PLANNING COMMISSION
SUMMARY MINUTES
JANUARY 9, 2024
5:00 P.M. Training and Organizational Session
7:00 P.M. Planning Commission Meeting

Bodega
12021 Sheraton Lane
PUD Amendment / Preliminary Development Plan
Application# 20230909
March 12, 2024

BODEGA
12021 SHERATON LANE
PLAN REVIEW PERMIT #20230909
24020103
FEBRUARY 27, 2024

PLANNING COMMISSION
ENGINEERING REVIEW

PLANTING PLAN
BODEGA AT SUGARCREEK
CROSSINGS OF SPRINGDALE
SPRINGDALE LAKE SUBDIVISION
CITY OF SPRINGDALE, HAMILTON COUNTY, OHIO

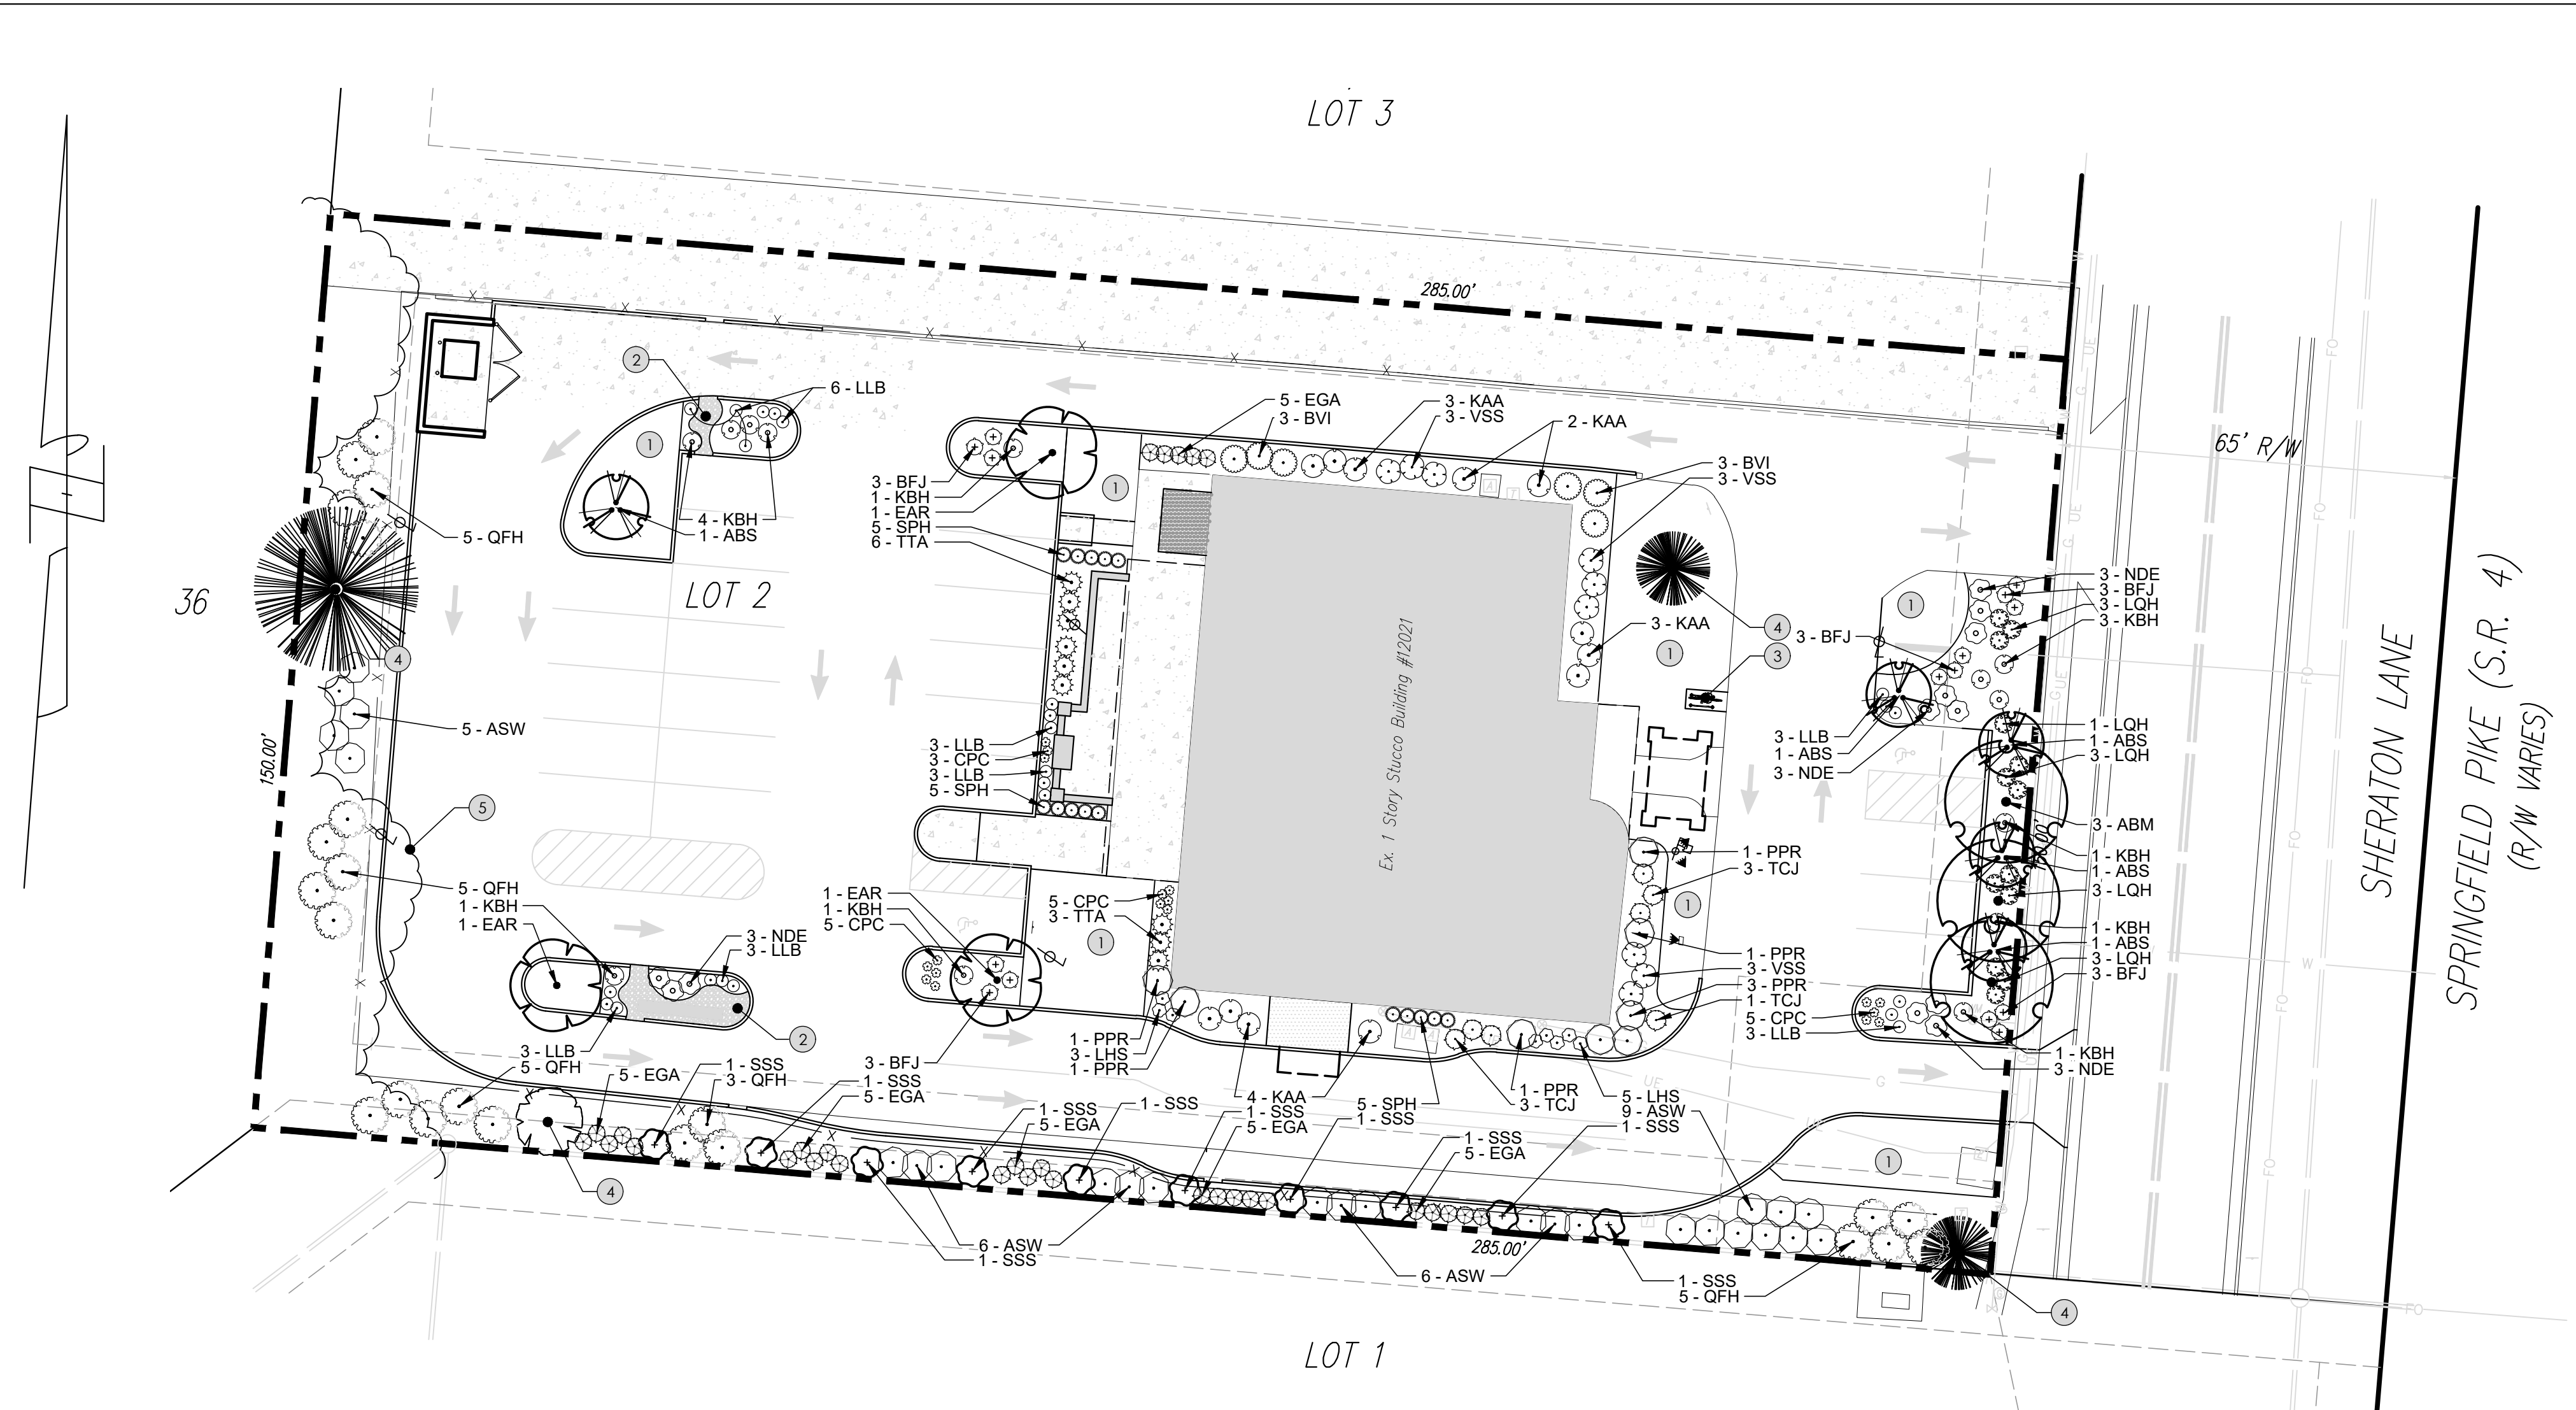
- 12) The applicant submitted a landscape plan to which staff has the following comments:
- A) Bufferyards are required for the west and south property lines for parking or access drives adjacent to residential use per Section 153. 404 (G) (1) Table 404-1. Bufferyard requirements for parking or access drive adjacent to a residential district or use, require a 20' wide yard with 1 canopy tree per 35' (or 1 ornamental tree per 25') and a double row of 6' hedge.

The requirements for the 127 lf of parking adjacent to a residential use is 4 canopy trees and approximately 84 shrubs (double row of 6' hedge). The existing conditions only provide an 18' wide yard instead of a 20' yard. Existing trees and treeline are identified on the landscape plan and on C-200 that "Existing Trees to Remain". No additional trees are required, but the 6' double hedge must be added where a vegetative buffer does not exist. Shrubs were added to this bufferyard for this submission, but they are not proposed as a double row of planting. A double row of planting is accurately depicted in this snippet of the landscape plan. Additional shrubs need to be added to the west bufferyard to meet the intent of the bufferyard requirements.

The requirements for the 256 lf of parking adjacent to a residential use are 11 ornamental trees and approximately 170 shrubs (double row of 6' hedge). The site plan provides a bufferyard that varies from 4.22' to 22' wide yard, instead of a continuous 20' bufferyard. The majority of the bufferyard width is 10' or less. A total of 12 trees (2 existing canopy trees and 10 ornamental trees) and 59 shrubs are provided. No trees are required to be added, however a double row of shrubs is not provided for the full length of the bufferyard. Additional shrubs need to be added to the south bufferyard to meet the intent of the bufferyard requirements, along with the required fence.

- C) Street tree plantings need to be provided in the State Route 4 Corridor Review District, 153.404 (F) in addition to the required bufferyard Section 153.404 (G) for the east property line. The required Street tree planting is 1 tree per 35' of street frontage. The 150 lf of frontage requires 5 trees. The required bufferyard for the east property line for parking or an access drive adjacent to a right-of way (public street) per Section 153. 404 (G) (1) Table 404-1, is 1 canopy tree per 35' (or 1 small/ornamental tree per 25') and 1 shrub per 3' in a 10' wide bufferyard. The bufferyard width varies from 7' to 26' wide. The plant material requirements for the 97 lf of bufferyard are 3 canopy trees and 33 shrubs. The total planting requirements for the east property line is 8 trees and 33 shrubs. A total of 5 trees and 33 shrubs are provided. An additional 3 trees are required.

- 3) The landscape plan be revised consistent with staff comments or as modified by Planning Commission.
- 4) Details of the proposed required screen fence or wall on the south property line be provided in compliance with Section 153.253 (E) (4) (f).

EX. COND., DEMO & TREE REMOVAL
BODEGA AT SUGARCREEK
CROSSINGS OF SPRINGDALE
SPRINGDALE LAKE SUBDIVISION
CITY OF SPRINGDALE, HAMILTON COUNTY, OHIO

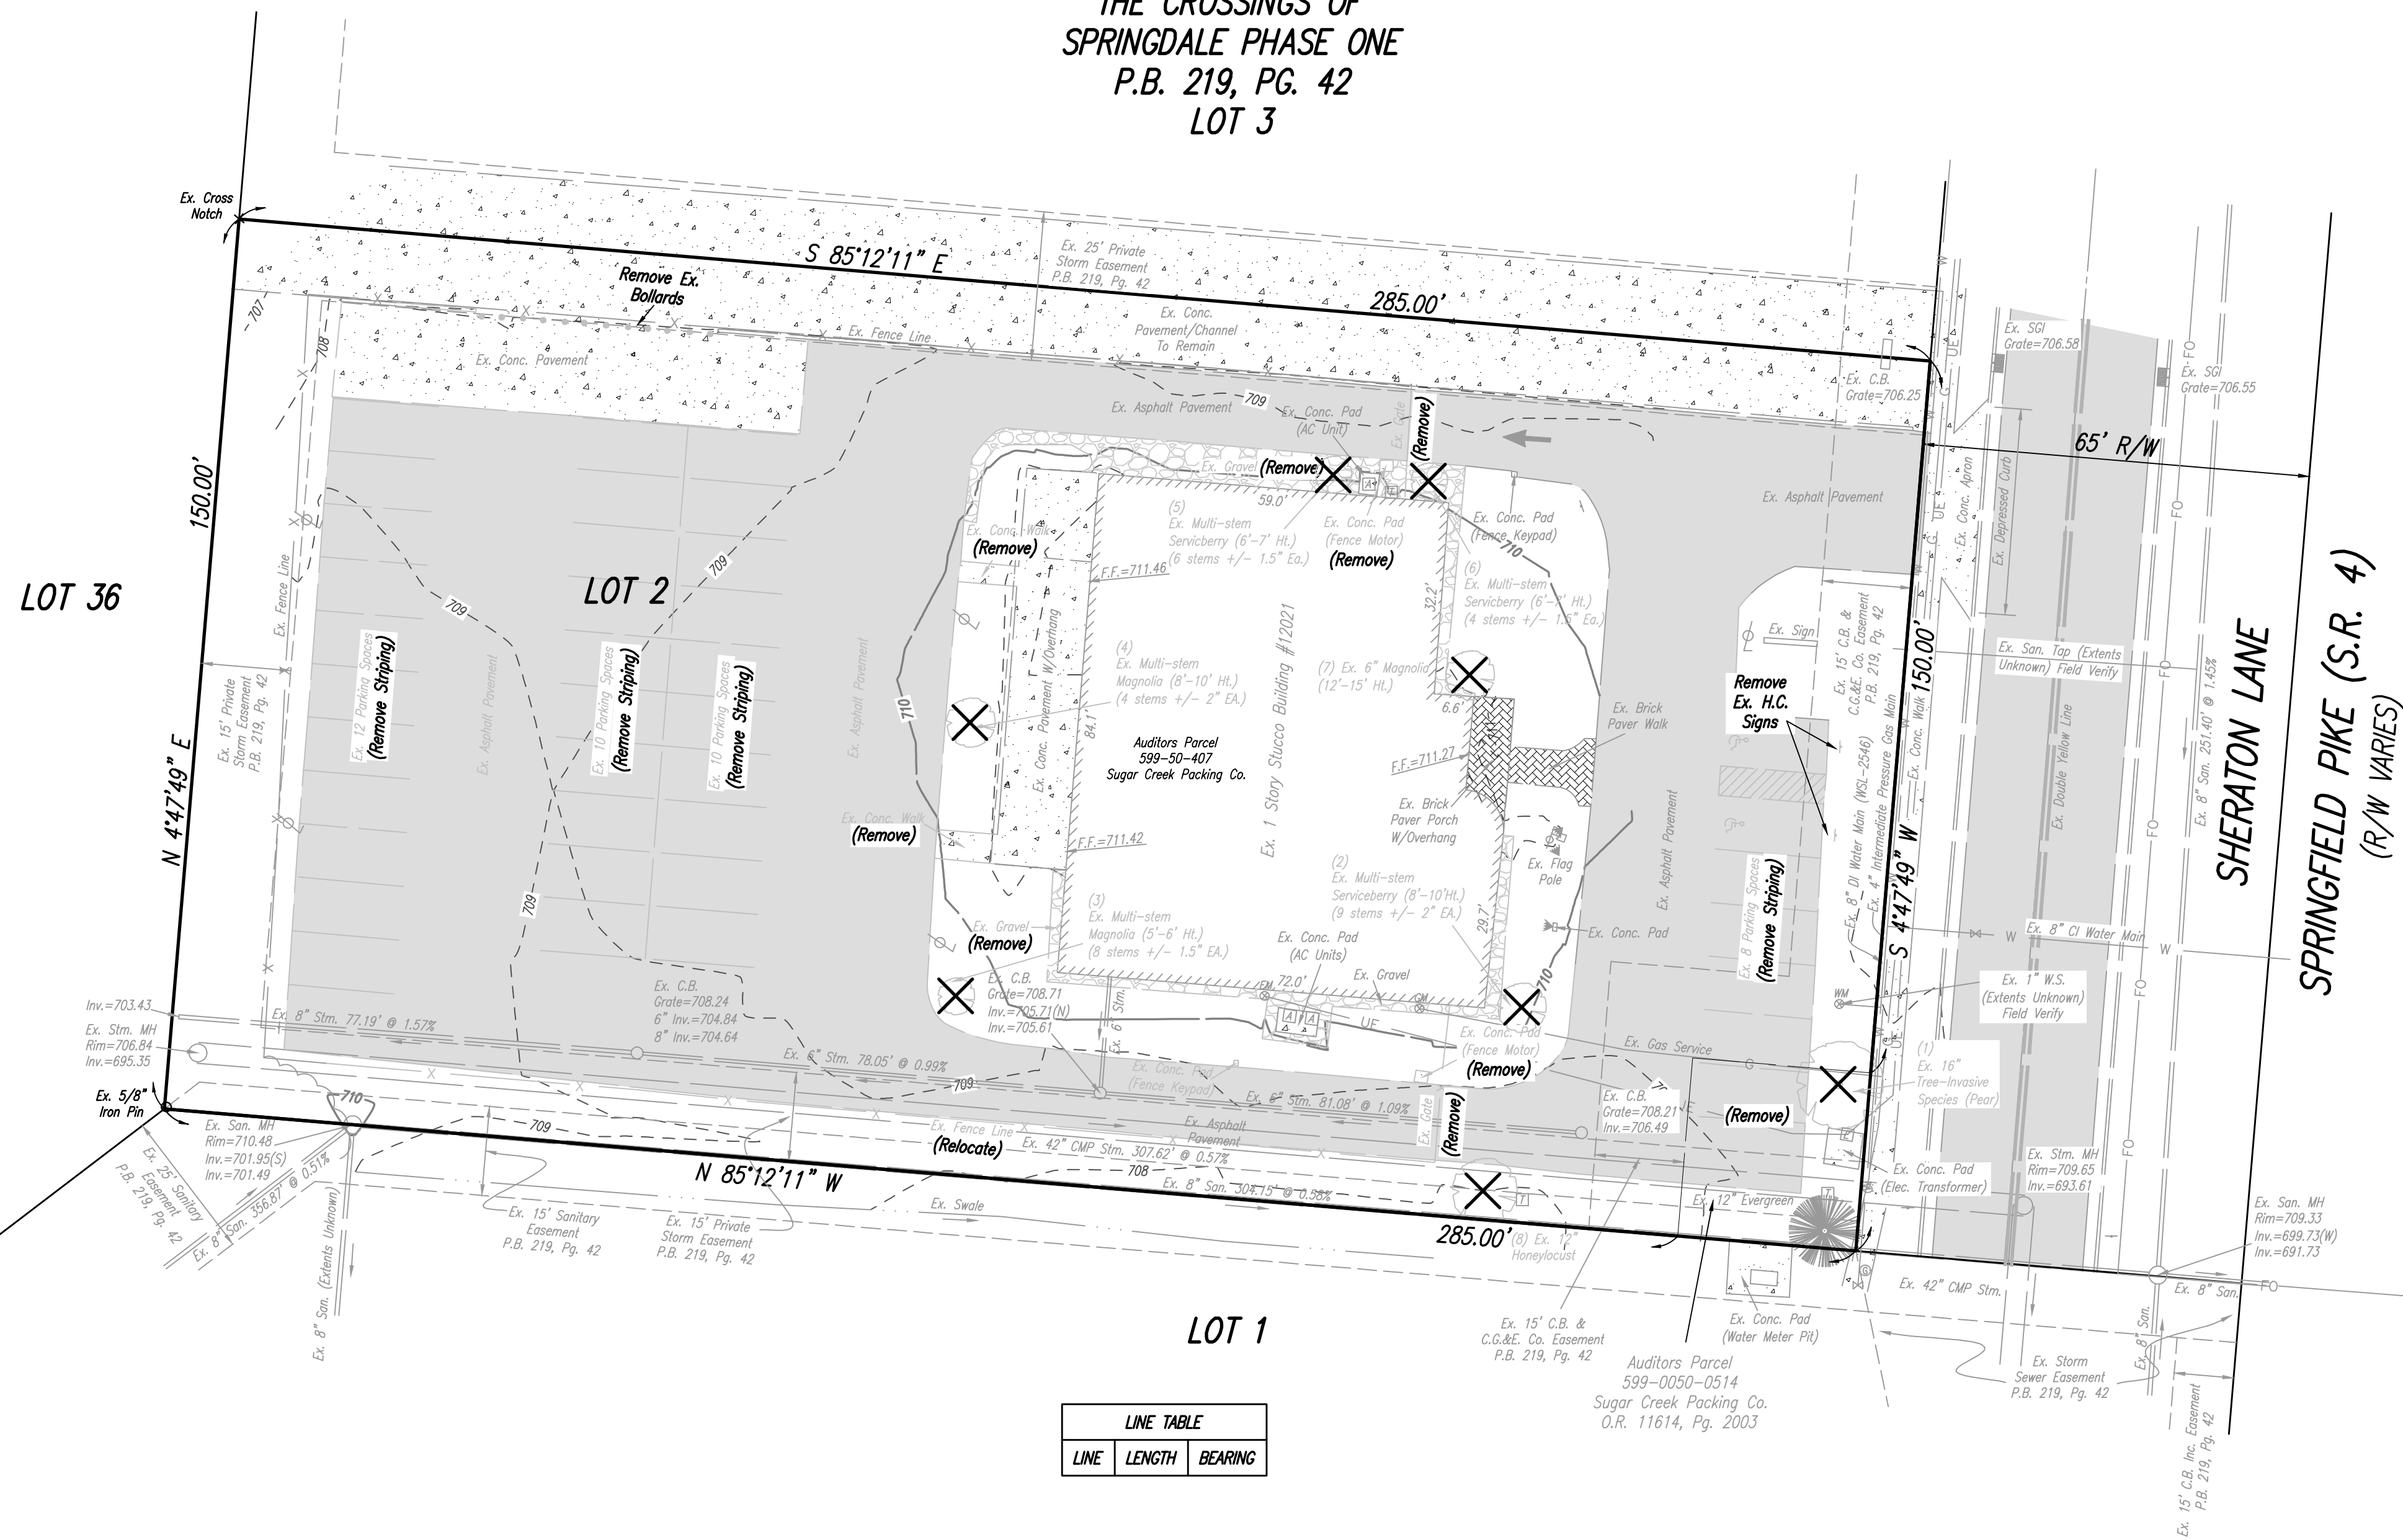
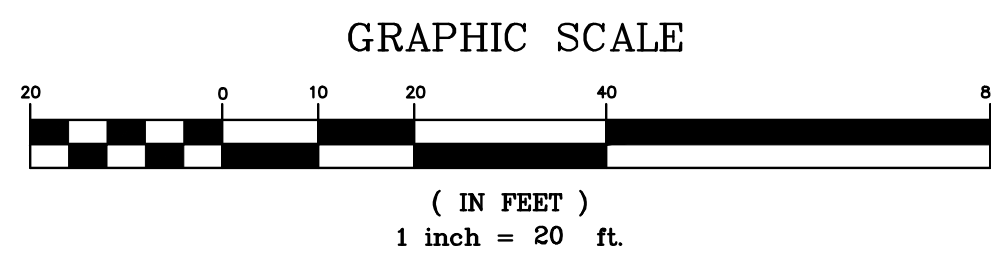
- D) Tree removal for redeveloped sites is required at one inch replacement for each one inch removed per Section 156.09. Sheet C-200 identifies that 26.5” of tree caliper are to be removed. The City has calculated 33 caliper inches are proposed on the current Landscape Plan, which meets the required replacement requirements.
- E) A landscape buffer needs to be added around the dumpster enclosure for sides that are visible from residential uses (the south and west elevations). To meet the intent of Section 153.254 (G) (9) which provides for additional requirements for screening service structures beyond Section 153.404 (D).
